Tennessee Valley Authority, 1101 Market Street, Chattanooga, Tennessee 37402-2801

March 22, 2000

TENNESSEE VALLEY AUTHORITY (TVA) NUCLEAR QUALITY ASSURANCE (NQA) PLAN - (TVA-NQA-PLN89-A) - PROPOSED REVISION - PLANT OPERATING REVIEW COMMITTEE (PORC) AND PLANT REVIEWS STANDARDIZATION

Tennessee Valley Authority NQA Plan - Applicable Section Both Marked-Up and Typed Copies

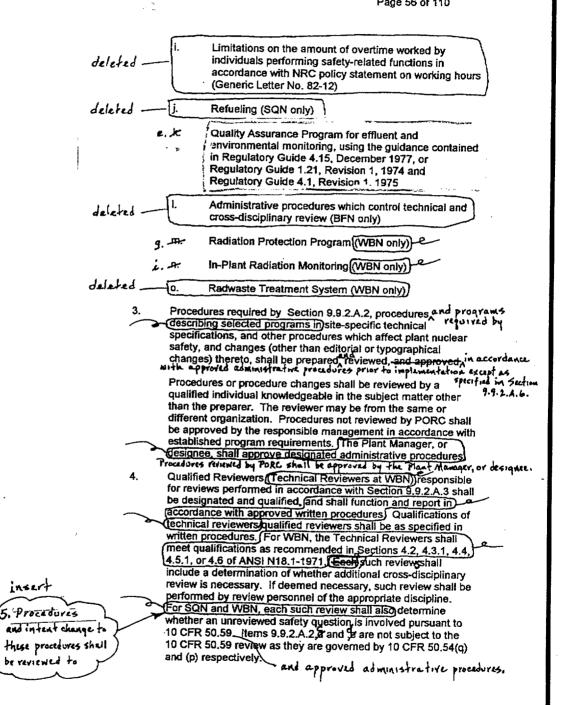
MARK-UP SHOWING CHANGES REV. 9-10/12/99 Pade 55 of 110 TVA-NQA-PLN89-A Page 55 of 110 PROPOSED TO STANDARDIZE REQUIREMENTS 9,9 Plant Reviews 9.9.1 General The plant staff organization provides reviews of day-to-day/activities to ensure they are conducted in a safe manner. (Technical Reviewers)Qualified Reviewers provide for reviews of procedures, procedure changes, and proposed changes to structures, systems, and components that affect nuclear safety in their area of expertise. The PORC is a multidisciplined committee responsible for providing an oversight review of documents required for the safe operation of the plant. PORC advises the Plant Manager on (all) matters related to nuclear safety. 9.9.2 Plant Reviews Α. Activities which affect nuclear safety shall be conducted as follows: Proposed changes or modifications to plant nuclear safety-1. related structures, systems, and components shall be reviewed in accordance with approved written procedures. Such modifications shall be reviewed by an individual/group other than the individual/group which designed the modification, but who may be from the same organization as the individual/group which designed the modification. Proposed modifications to plant nuclear safety-related structures, systems, and components shall be approved by the Plant Manager, or designee, prior to implementation. 2. Written procedures shall be established, implemented, and maintained covering the activities reformed below: following activities: a. The applicable procedures recommended in Regulatory Guide 1.33, Revision 2, Appendix A, February 1978 and in accordance with Appandix B of this Plan; The emergency operating procedures which implement b. NUREG-0737 and NUREG-0737, Supplement 1, as stated in Generic Letter 82-33 Surveillance and test activities of safety-related deleted equipment d. Radiological Emergency Plan Implementation C. 8. Security Plan Implementation Offsite Dose Calculation Manual (ODCM) deleted -Implementation f, 8: Fire Protection Program Implementation h. Process Control Program Implementation (radwaste packaging and shipping); and
